**RE: Wilshire Place Subdivision
Conceptual Grading and Drainage Plan
Engineer's Stamp Date: 08/10/18
Hydrology File: C18D103**

Sheet Title
**DRAINAGE AND
CONCEPTUAL GRADING PLAN**
Date
AUGUST 10, 2018
Project No.

Sheet Number
SP2

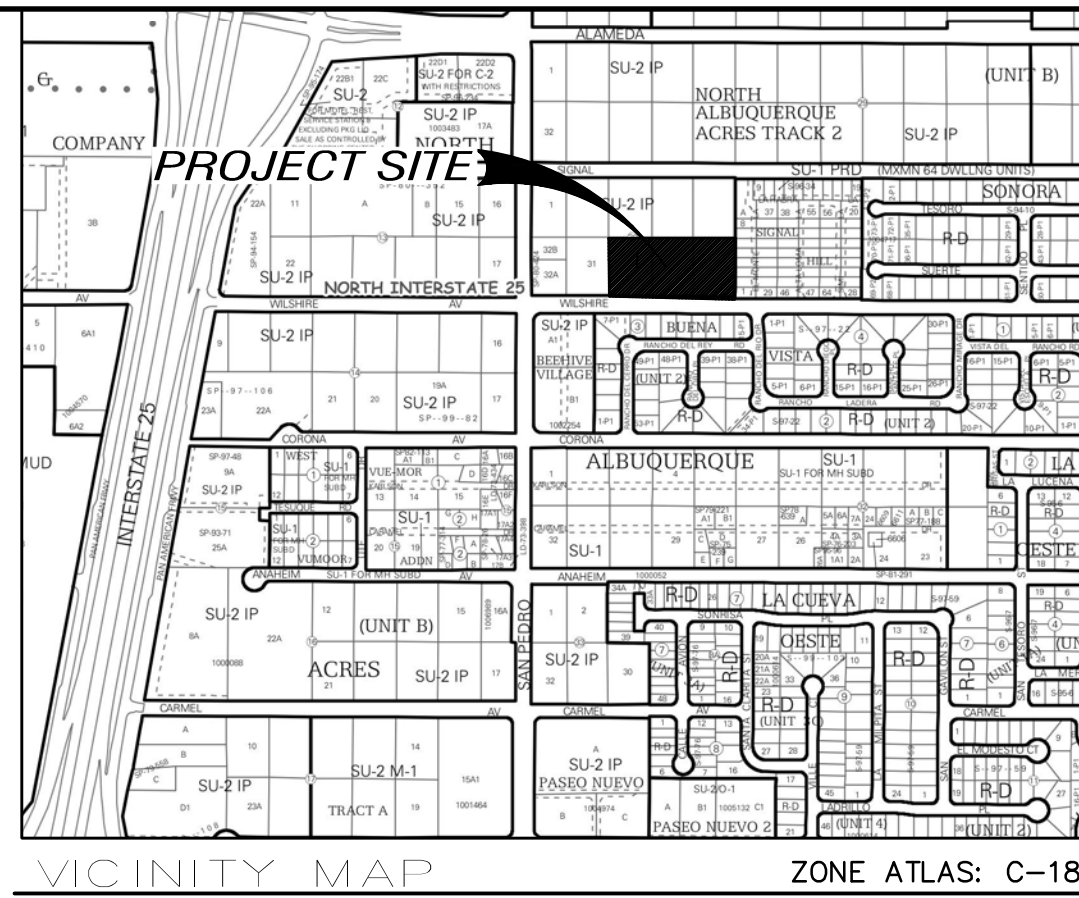
Based upon the information provided in your resubmittal received 08/14/2018, the Conceptual Grading and Drainage Plan is approved for action by the DRB on the Preliminary Plat and Site Plan for Building Permit.

Please remember that an Erosion and Sediment Control Plan is required and has to be submitted to the storm water quality engineer (Curtis Cherne, PE, ccherne@cabq.gov) prior to Hydrology's approval for Work Order.

Also prior to Certificate of Occupancy, a Private Facility Drainage Covenant per Chapter 17 of the DPM for the underground detention and first flush must be provided to Hydrology.
